August 23rd, 2019

RE: Reply Comments on Xcel Energy's May 1, 2019 Filing on the Calculation of the Avoided Distribution Cost Component of the Value of Solar (Docket No. M-13-867)

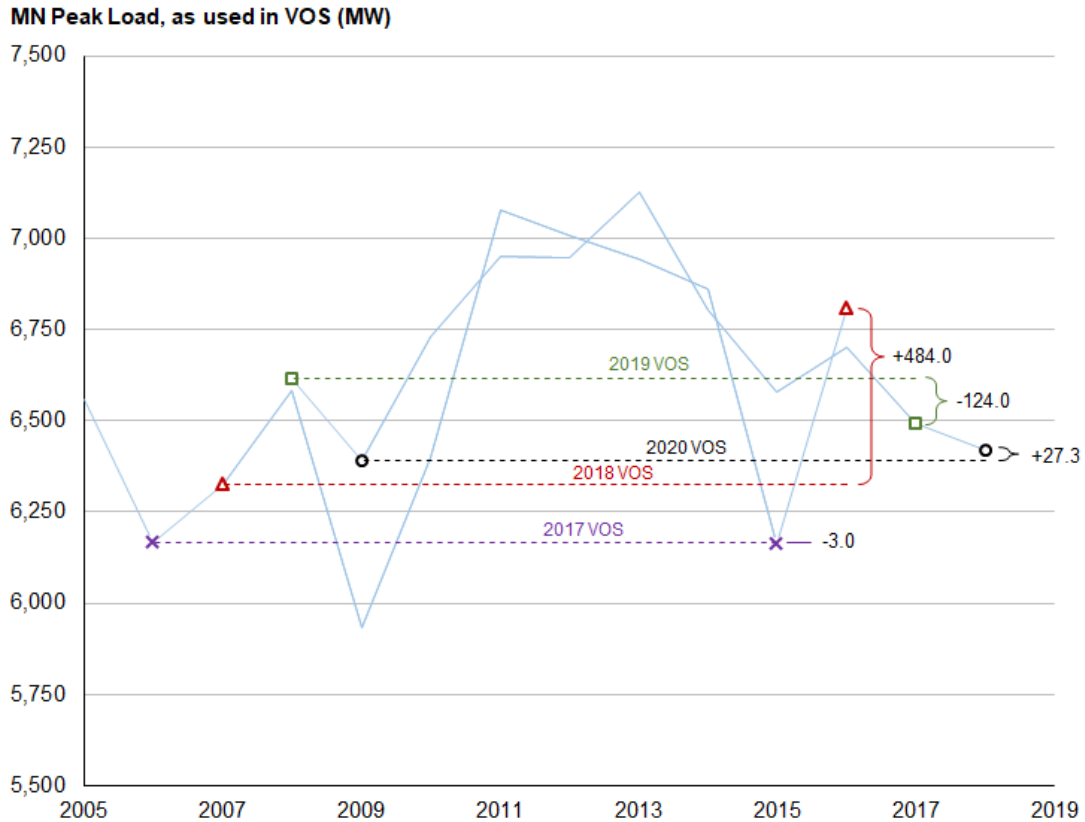
The most recent calculation of the avoided distribution cost under the current method demonstrates how relying on just two data points of peak load can yield volatile results. The fundamental statistical rationale is that the maximum of a distribution (in this case, the maximum of total annual load) has a high variance. Peaks are highly variable from year to year, as demonstrated in Figure 2, and therefore the difference between two peaks is not a statistically reasonable approximation for peak growth rates.

A more reasonable approach to incorporating notions of peak load growth would be to utilize assumed fixed growth rates, as is done in the Integrated Resource Plan (IRP). Figure 3 below replicates a figure from the 2019 Xcel Energy IRP that shows an average ~0.2% annual peak load growth rate. This growth rate is net of energy efficiency, but it is conceptually unclear if energy efficiency should be included or excluded in the determination of peak load for the purposes of the VOS¹².
